SERVICE BULLETIN

FUJI HEAVY INDUSTRIES LTD.

NO. 200-007

: Addition of Stops to Fuel Selector Valve Cover SUBJECT

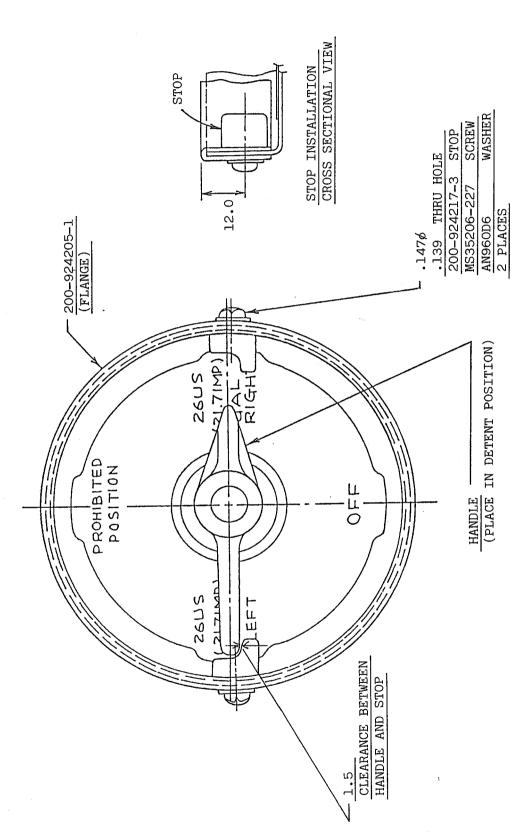
(1) Drill two (2) stop attaching holes as shown on the attached figure 1.

CAUTION

For safety precaution, use hand drill or air drill for drilling. Flange can be easily drilled as it is made of soft alluminum alloy (6061-0).

Take precaution to prevent metal chips (caused by drilling) from sticking to fuel selector valve shaft.

- (2) Make a 12.0 mm (concentric) dia cutout in rubber of inside flange only.
- (3) Install stops with screws and washers as shown on the figure 1.
- (4) Make a log book entry indicating completion of this bulletin.
